UNITED STATES PATENT AND TRADEMARK OFFICE

Office Action Summary

10/824,124

DETAILED ACTION

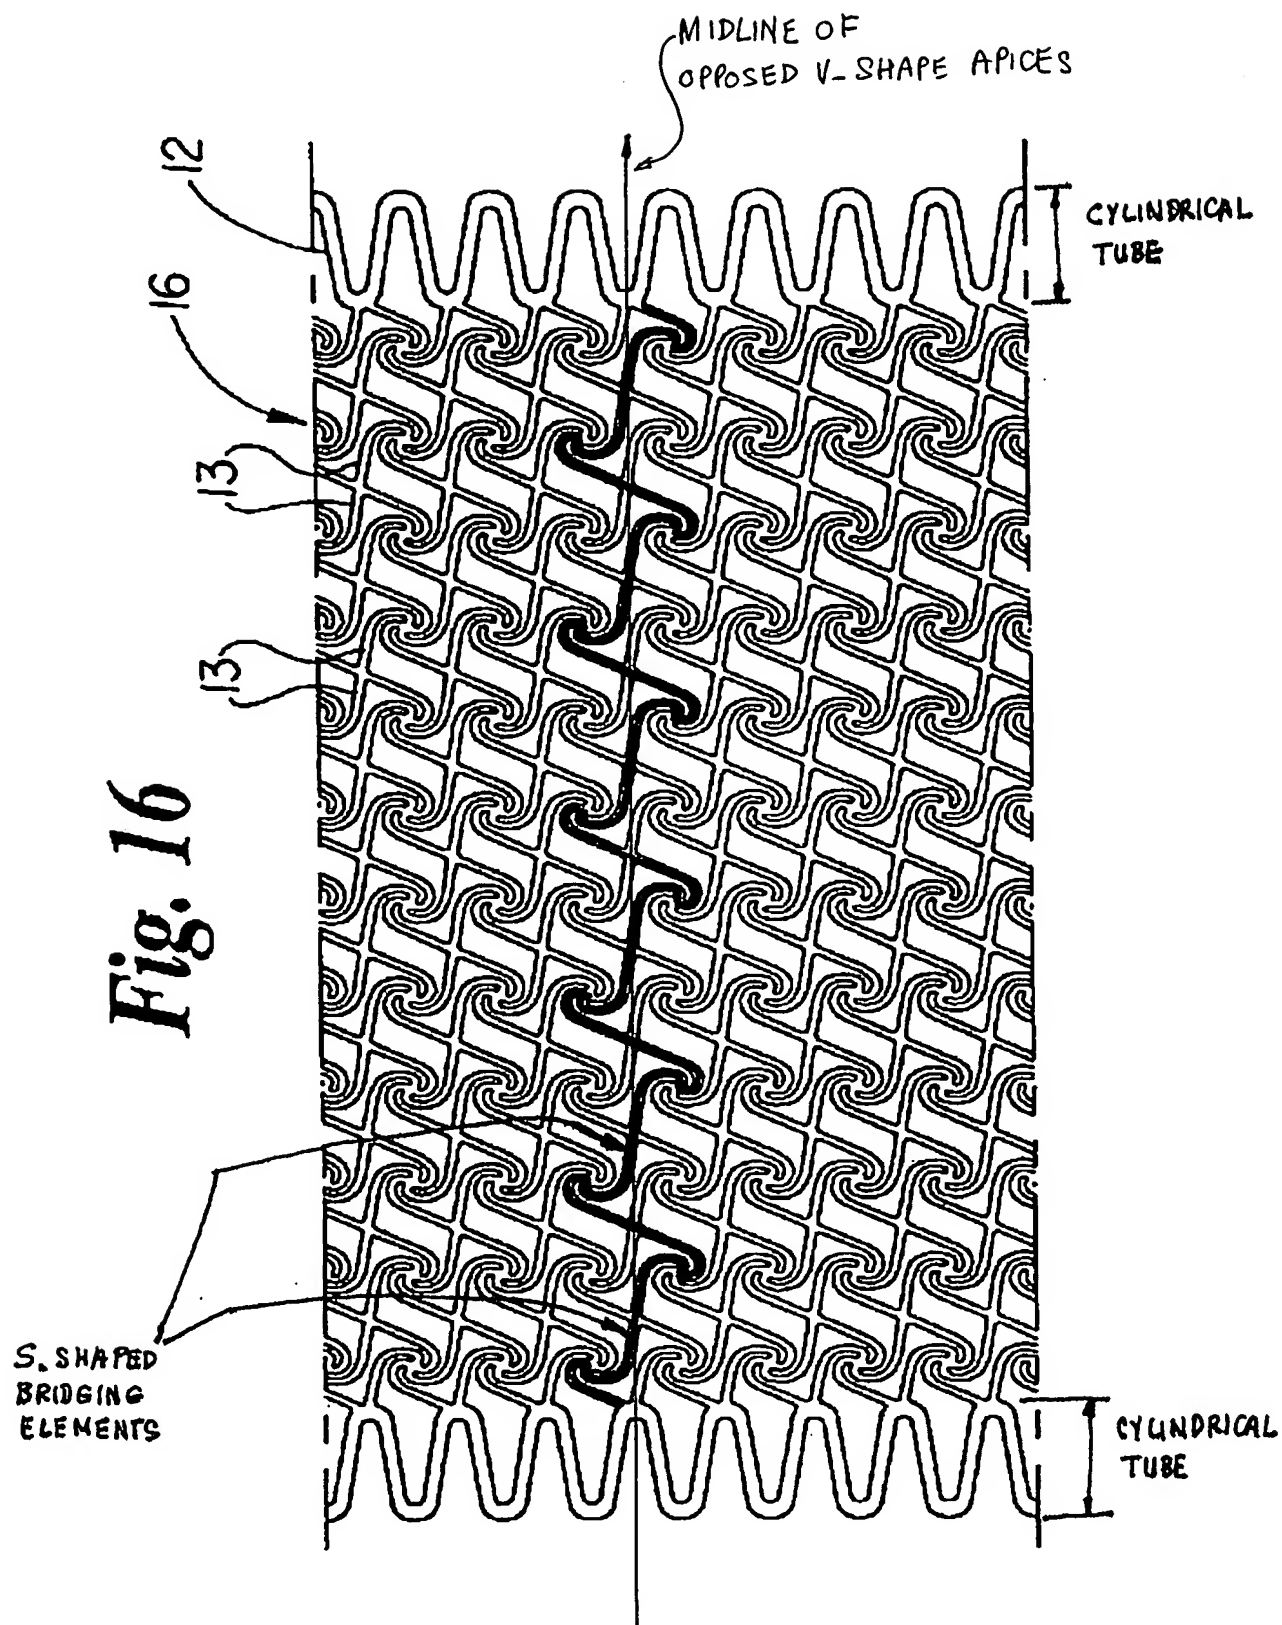
Claims 1-10 and 17 are rejected under 35 U.S.C. 102(e) as being anticipated by Her et al-6,033,433.

As to claims 1-10 and 17, Ehr-'433 (please refer to Fig. 16 reproduced on next page) discloses a stent having S-shape bridging elements crossing three times midlines of V-shapes as recited in the claims.

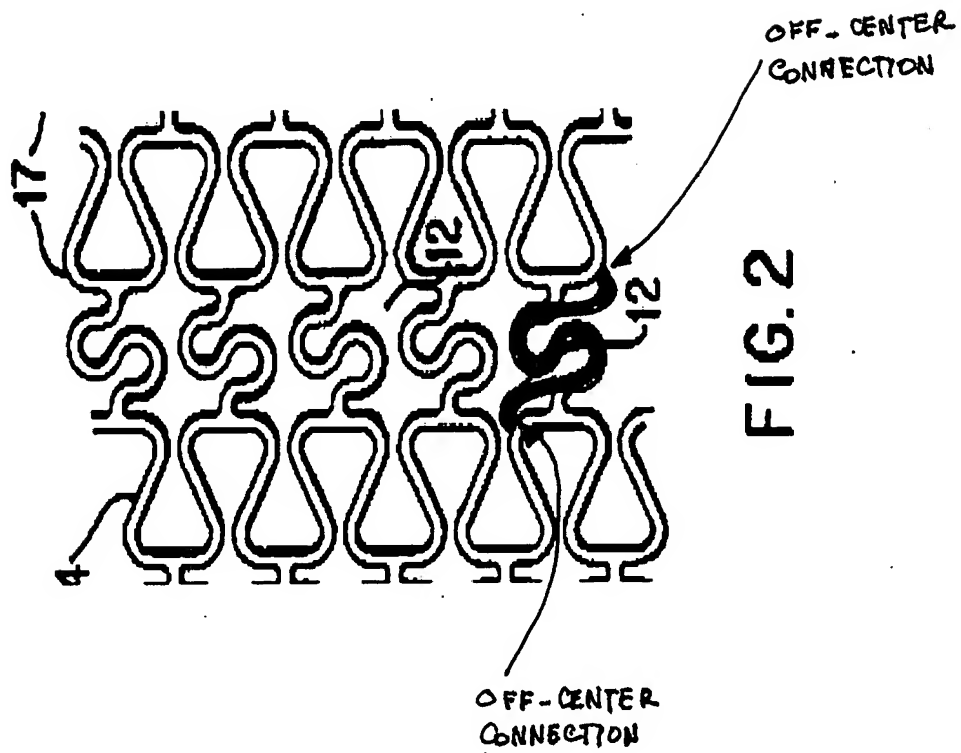
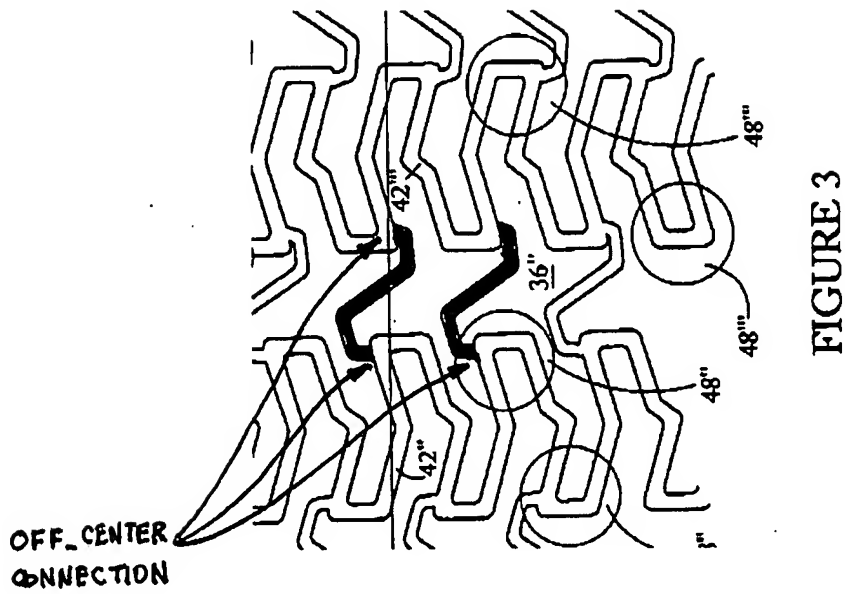
Claims 10-16 are rejected under 35 U.S.C. 103(a) as being unpatentable over Fischell et al.-5,697,971 in view of Jang-6,235,053.

As to claims 10-16, Fischell-'971 (Figs. 2-3) discloses a stent 10 having cylindrical tubes having adjacent struts and S-shaped bridging elements substantially as recited in the claims, except for the connecting points of the S-shaped bridging elements located diagonally and bridging element less wider than strut as recited in the claims. However, Jang-'053 (Fig. 1-3, for example) discloses connecting points of the S-shaped bridging elements located diagonally (off-center connection) and S-shaped bridging elements less wider than adjacent struts. It would have been obvious to one of ordinary skill in the art at the time of the invention to move the connecting points to the locations as shown in modified Fischell-'971 stent in view of Jang-'053 (please, see Fig. 2 on next page) for this modified configuration is just another choice of design for Fischell-'971 stent in view of Jang-'053.

The arguments asserted that the modification of Fischell-'971 in view of Jang-'053 was improper because the combination of Fischell-'971 and Jang-'053 do not teach the claimed invention, especially the cells 12 of a modified Fischell-'971 stent in view of Jang-'053 will block a branch artery.

The modification in the previous "Office Action" suggested a modification of the locations of the connections between a Fischell-'971 S-bridge to the struts to modified locations as taught by Jang-'053, this modification will not block a branch artery against Fischell-'971 teaching, but in fact even give more room for cells 12 to expand for a branch artery, because the modified Fischell-'071 S-bridges in view of Jang-'053 are now longer and have more stored length for expansion.

Again, in view of Jang's teaching to connect S-shaped bridging elements at location diagonal to the longitudinal axis of the stent, it would have been obvious to one of ordinary skill in the art to modify a Fischell's stent to have two connecting points diagonal to the longitudinal axis of the stent as this configuration would not destroy the function of the Fischell's stent.
